BCA ASSESSMENT REPORT

Coopers Paddock
Governor Macquarie Drive, Warwick Farm

Client: STOCKLAND

Revision 0

Figure 1 - Areas of Non-Compliant Perimeter Vehicular Access per BCA C2.4.

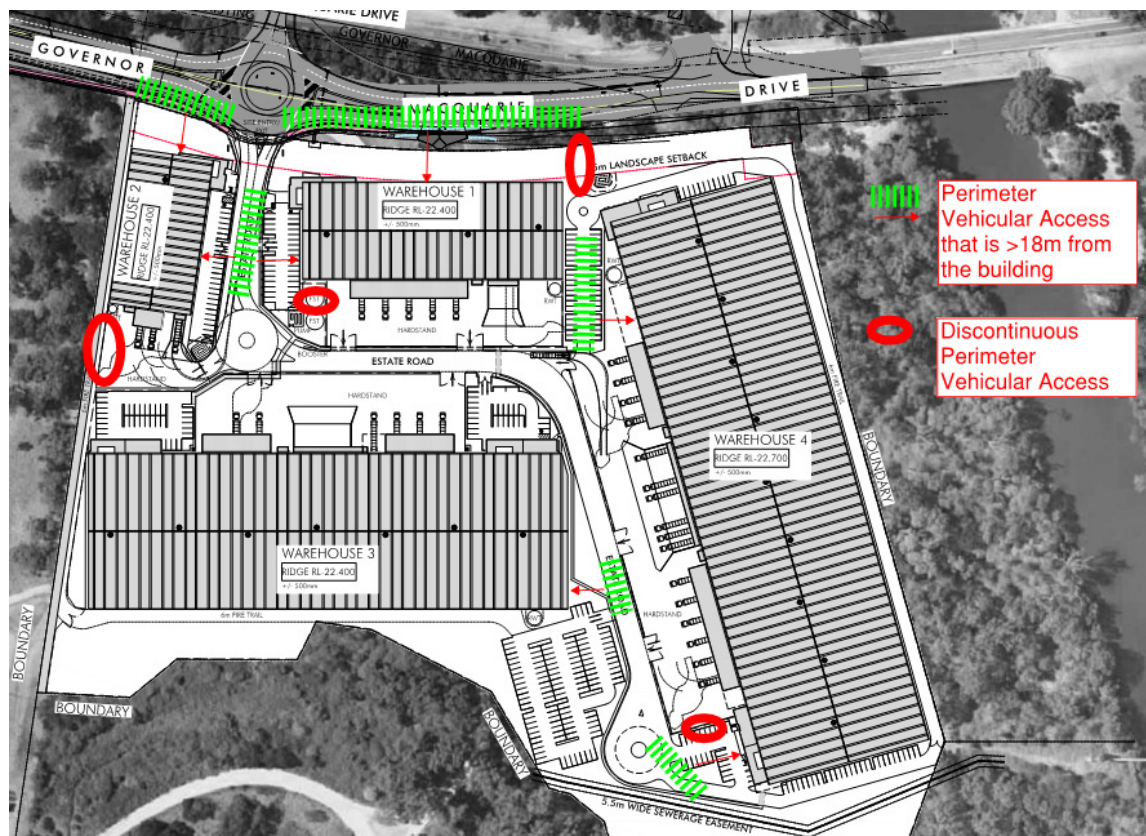
Comments: The proposed warehouse buildings do not comply with the provisions of C2.4 and thus the following non-compliance issues are required to be addressed as an alternative solution by the Fire Safety Engineer to demonstrate compliance with Performance Requirement CP9 - refer to the dot points and the diagram below for details of the proposed non-compliance issues:

- Vehicular Access is provided around the four (4) sides of all of the Warehouses & however, it is discontinuous in 4 separate locations on one corner of Warehouse 1, 2, 3, & 4 - refer to diagram below.
- Vehicular Access is greater than 18m from the external wall of Warehouse 1, 2, 3, & 4 - refer to diagram below.
